Nine Mile Point Nuclear Station, Unit 2
Renewed Facility Operating License No. NPF-69
Docket No. 50-410

Subject: Response to Request for Additional Information Nine Mile Point Nuclear Station License Amendment Request for Maximum Extended Load Line Limit Analysis Plus

ATTACHMENT (2)
RESPONSE TO NRC REQUEST FOR ADDITIONAL INFORMATION (Non-Proprietary)

Figure 2-1. Graphical Depiction of the SLMCPR Evaluation Statepoints

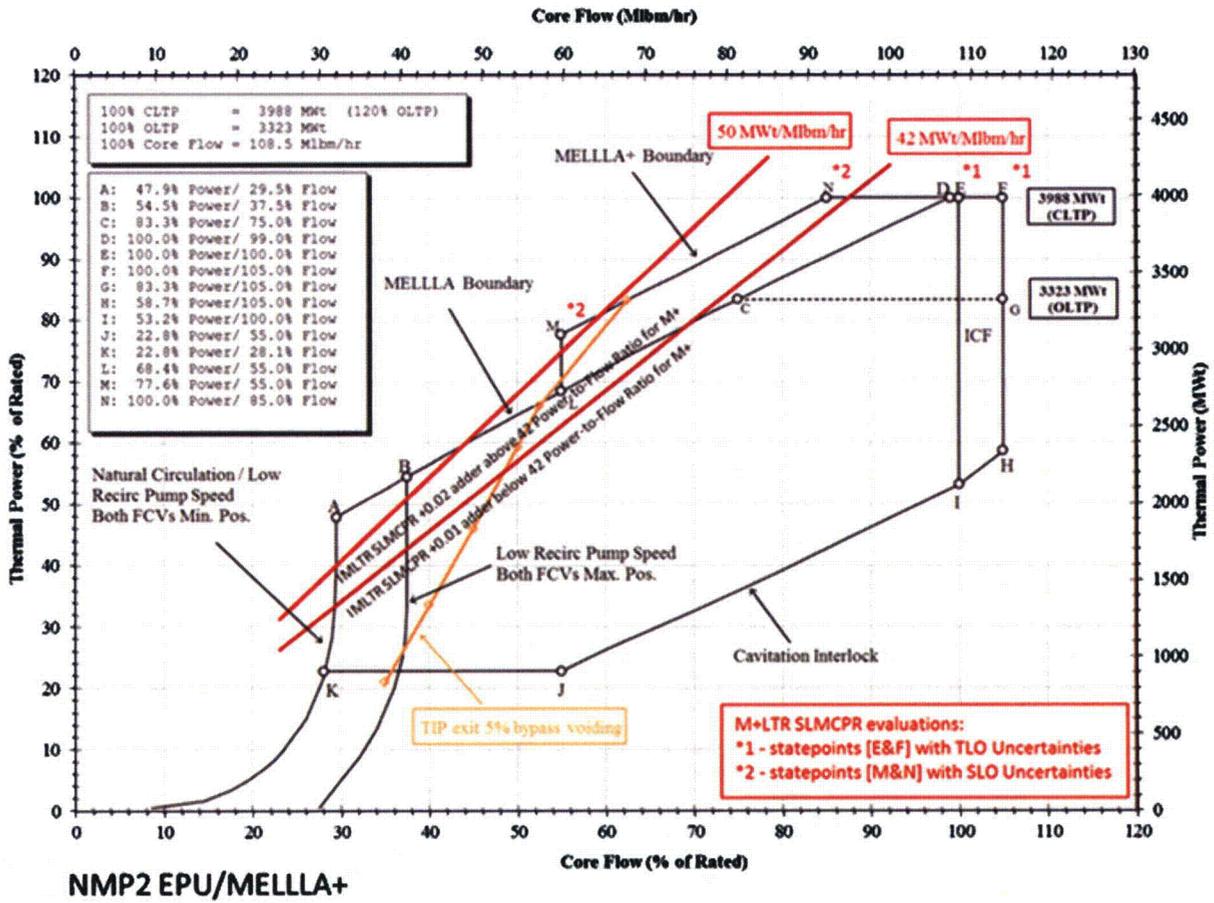
Section 2.2.1 "Safety Limit Minimum Critical Power Ratio" states that "a +0.02 SLMCPR adder will be added to the cycle-specific SLMCPR."

- 1. Provide a list of SLMCPR adders in MELLLA+ with respect to Original Licensed Thermal Power (OLTP) conditions.*
- 2. Specify which adders are part of the Extended Power Uprate (EPU), and which are MELLLA+ specific.*
- 3. In addition, the Methods SER specifies a SLMCPR adder of 0.03. Please explain the difference between the 0.03 and 0.02 values.*

Figure 2-1 shows a graphical depiction of the SLMCPR evaluation statepoints and the Methods LTR penalties applied based on Power-to-Flow Ratio (P/F) value. Statepoints M&N [*2] in Figure 2-1 apply a +0.02 SLMCPR adder. Statepoints E&F [*1] in Figure 2-1 apply a +0.01 SLMCPR adder. Statepoints N, E, & F are evaluated at the rated power condition of 3988 MWth (100% CLTP or 120% OLTP). Statepoint M is evaluated at the off-rated power condition of 3095.5 MWth (77.6% CLTP or 93.2% OLTP).

NMP2 has elected to conservatively apply a +0.02 SLMPCR adder to all evaluation points as noted by the statement in the M+SAR that "a +0.02 SLMCPR adder will be added to the cycle-specific SLMCPR." The NMP2 Cycle 15 Tech Specification change letter (Reference 2-2) Table 3 notes the application of this adder to each evaluation statepoint shown in Cycle 15.

Figure 14-1. NMP2 MCO (Moisture Carryover Wt. %) at EPU Rated Power

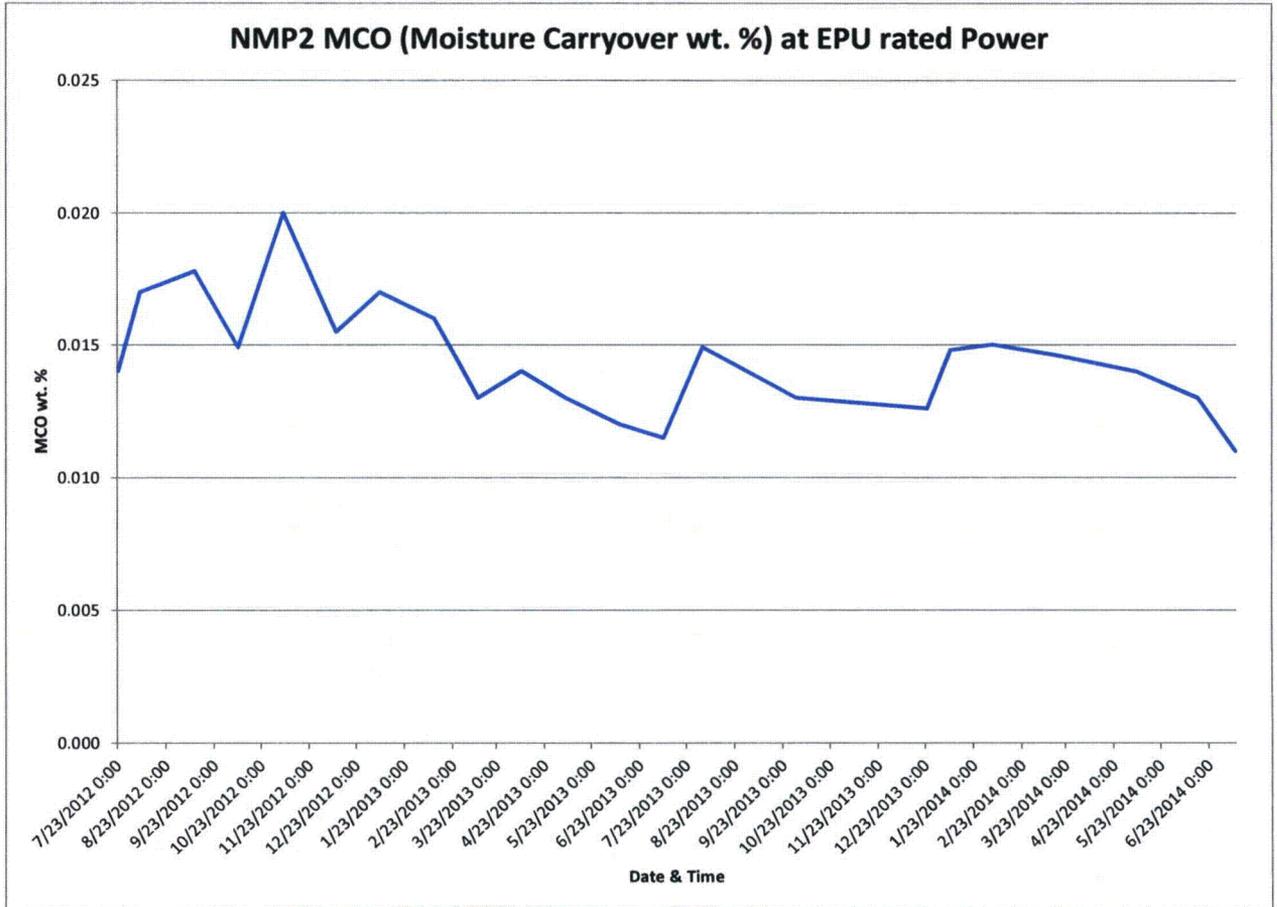
- c. *What plant operations are used in NMP2 to minimize the moisture carryover, MCO?*
 - d. *Provide a short physical explanation of what causes the increased moisture carryover, MCO, at lower flow. Is this mechanism predicted using an experimental correlation or a first principle analytical tool?*

- 3.c. Historical and current reactor core design practice for each NMP2 reload is to limit radial peaking factor to less than 1.6. This is typically achieved thru the core loading and rod patterns prescribed for the operating cycle. This approach has resulted in MCO much less than 0.10 wt. %. The standard MCO trending measurement is monthly. The current NMP2 EPU MCO based on this trending is shown in Figure 14-1.
